## COMPONENT TASK EVALUATION REPORT

COMPONENT NO. 03-341A D.G. 101	TDI PART NO. 03-341A	INITIATOR <i>Kevin M. Felt</i> SIGNATURE	DATE 3-21-84	ORGANIZATION <input type="checkbox"/> ENGINEERING <input checked="" type="checkbox"/> QUALITY
--------------------------------------	-------------------------	--	-----------------	---

SYSTEM(S) OR PART(S) NAME	LOCATION(S)
COMPONENT NAME:  <u>Pistons</u>	<u>DC-101</u>
COMPONENT NO. <u>03-341A</u>

Date: 1 MARCH 1984 S-42  
To: JOHN KAMMEYER  
From: DON SCHMITZ  
Subject: EMERGENCY DIESEL GEN #102- SN 74011  
MECHANICAL WEAR ON VARIOUS COMPONENTS  
LDR- 2147, 2146, 2145, 2144, 2143

REFERENCE  
DOCUMENT(S)Piston Skirt  
3 (03-341-04-A2)

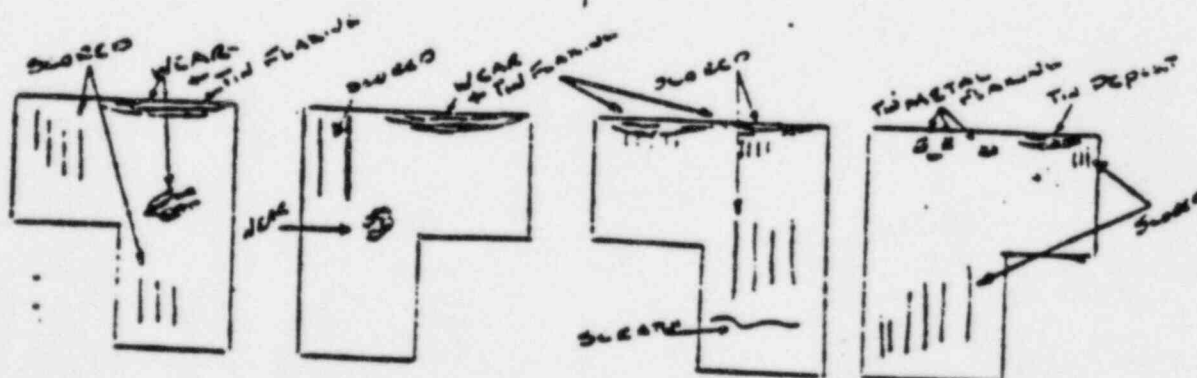
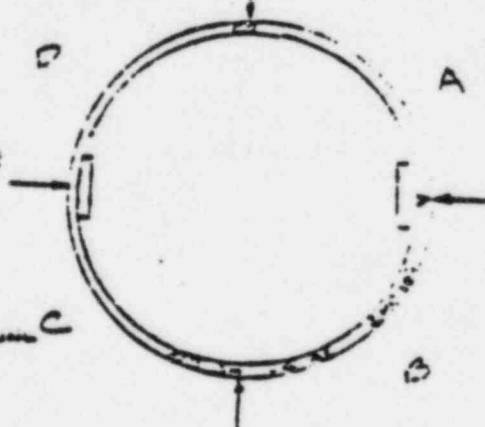
PERFORMED VISUAL INSP. ON O.D. OF PISTON SKIRT AREA  
FOR ABOVE REF. PISTON BELOW FIND THE INSP. RESULTS.

O.D. SURFACE  
SLIGHT WEARMARKS  
SMALL SCALLOPS & SCRATCHES  
AREAS ALONG WITH  
SURFACE TIPPING FLAKES

ITEM(S) OR PART(S) NAME	LOCATION(S)	REFERENCE DOCUMENT(S)
PISTON SKIRT (03-341-04-AL) VISUAL INSP.  273 lbs.	DL 102	OH1-089 I.P. - 03-341-04-AL -14 2/12/84

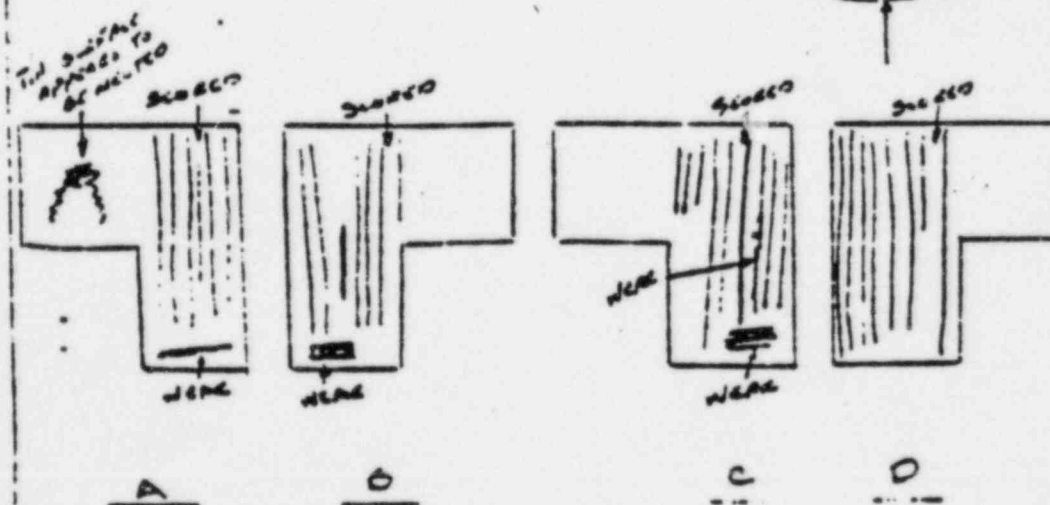
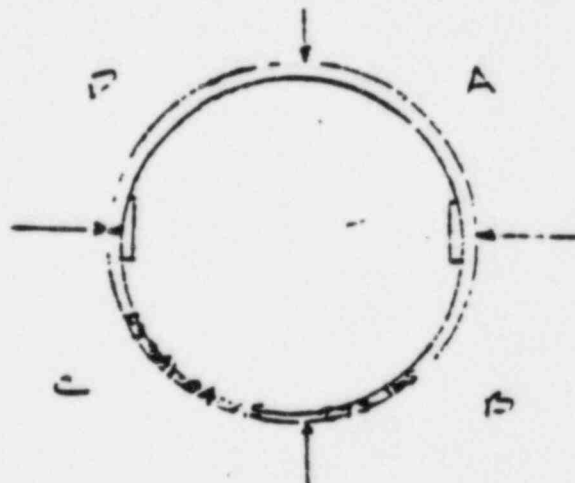
ITEM QTY	DESCRIPTION(S) AND INSPECTION REMARK(S)
	PERFORMED VISUAL INSP ON O.D. OF PISTON SKIRT AREA FOR ABOVE REF. PISTON. BELOW FIND THE INSP. RESULTS.

SLIGHT WEARMARKS, SHALLOW  
 SLEECED & BLEACHED AREAS.

THICKENED SURFACE WORN IN SPOTS

REFERENCE  
DOCUMENT(S)SYSTEM(S) OR  
PART(S) NAMEPISTON SKIRT  
#B (03-341-04-AE)  
VISUAL INSP.

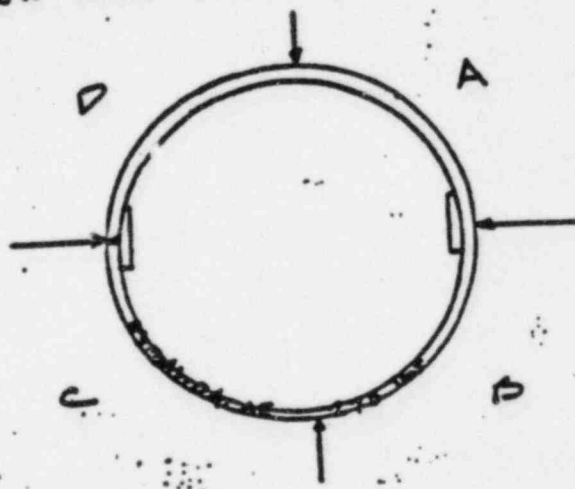
PERFORMED VISUAL INSP. ON O.O. OF PISTON SKIRT AREA:  
FOR ABOVE REF. PISTON. BELOW FIND THE INSP. RESULTS.

SLIGHT WEARMARKS, SHALLOW  
SCORED & SCRATCHED AREAS.

TURNED SURFACE WORN IN SPOTS.

THE SURFACE  
APPEARS TO  
BE UNIFORM

No More Information is required for  
Design Review K. Solon for C. Wells  
Conversation 3/1
